50 AMP Smart Energy Management System[™] Model 700 / 800 / 900

INSTALLATION & SERVICE MANUAL ERRATA

DIP SWITCH S1 SETTINGS:

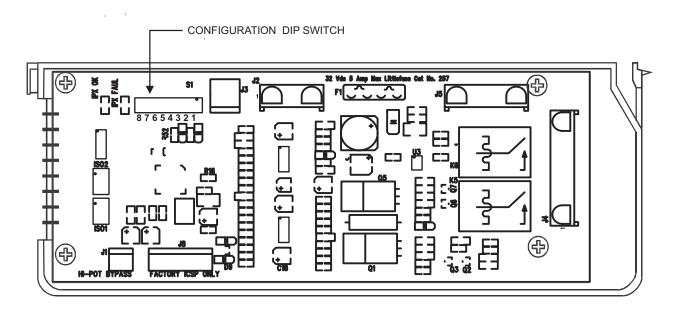
The Installation and Service Manual for the Smart EMS System describes the functionality of each switch position on Dip Switch S1 that has defined function. Starting Feb. 23, 2007 (Julian date code 05407), position 7 has been defined for a 3rd air option feature (previously a reserved position).

When position 7 is in the off position, the 3rd air option is enabled. When position 7 is in the on position, the 3rd air option is disabled.

When the 3rd air option is enabled, the functionality of this option is as follows:

When service is 30Amps or less, relay1 is disabled (off state) where relay 1 has been wired for a 3rd air conditioning unit. Also the LED on the display unit will be off for relay 1.
